# Jemena Gas Networks (NSW) Ltd

## Revised 2020-25 Access Arrangement Proposal

Attachment 13.1

Response to the AER's draft decision - Demand

**Figure 3-1 Penetration rate over the 2008-19 period**

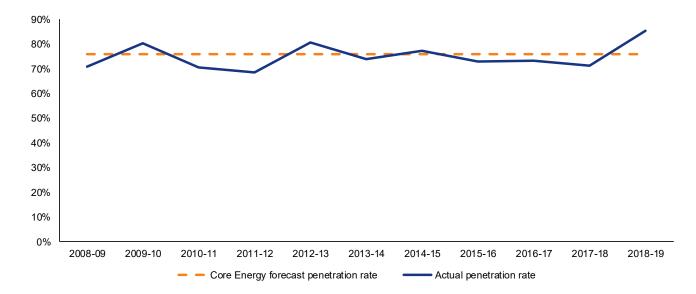
We note that the AER observed a downward trend in the penetration rate for each of years between 2012–13 to 2017–18 and considered that "*Although the correlation is not as strong in some years compared to others, the downward trend is consistent enough in recent years to warrant a more in-depth review…*"[17]

As shown in Figure 3-1, looking only at the data from 2012-13 to 2017-18, there does appear to be a downward trend in the penetration rate. However, we would note that the trend looks quite different over different periods. For instance, even changing the starting year by one year would suggest a different conclusion: the apparent trend over the period from 2011-12 to 2017-18 and the period from 2013-14 to 2017-18 looks quite different to the apparent trend over the period from 2012-13 to 2017-18. This suggests that caution should be used in concluding that there is a genuine trend in the historical data on penetration rates; this data is, after all, quite variable.

The penetration rate for 2018-19, which is now available, confirms the risk of concluding that there is a trend to the historical data on penetration rates. The penetration rate for 2018-19 was higher than the penetration rate for any of the previous 10 years (this is largely due to the completion of a number of apartment buildings in 2018-19). Revisiting the apparent trends in the historical data with this most recent year provides a different picture again: one of increasing penetration rates.

**Figure 5-1 High-rise dwellings connected by sub-segment (%) actual and forecast**

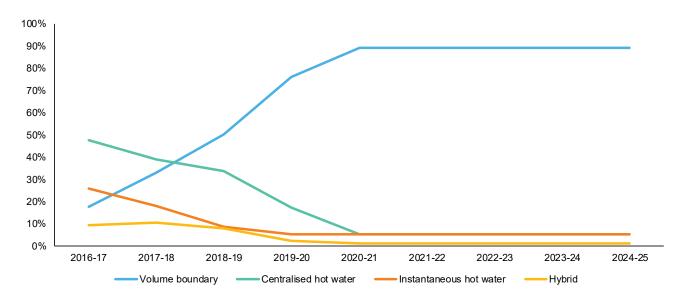
As a result of that decision, the AER changed Core Energy's demand forecasting model. The AER requested that we clarify whether they had adjusted Core Energy's model appropriately and the impact of JGN's volume boundary metering strategy on connection numbers and demand.[23]

Based on the historical trends shown in Figure 5-1, and high-rise construction timelines (where projects can take anywhere from two to five years to construct[26]) Core Energy is forecasting that uptake of our volume boundary product will increase. This is partly because the take-up of volume boundary metering has continued to rise year-on-year.

- The number of sites supplied by volume boundary metering will continue to grow before holding steady at 89% in 2021-22.

- The proportion of centralised hot water dwellings will fall to 5% as only a minority of developers will opt to install individual hot water metering, given this option costs developers more (they have to pay for the hot water plant) and reduces the size of the dwellings for sale (as additional space is required for our metering assets).

- The proportion of instantaneous hot water dwellings will continue to fall (following a demonstrated historical trend), from 9% to 5% by 2020-21, after which time the percentage is expected to remain relatively constant.

- The number of hybrid sites will fall to 1%, reflecting the historical ratio of hybrid to centralised hot water sites.
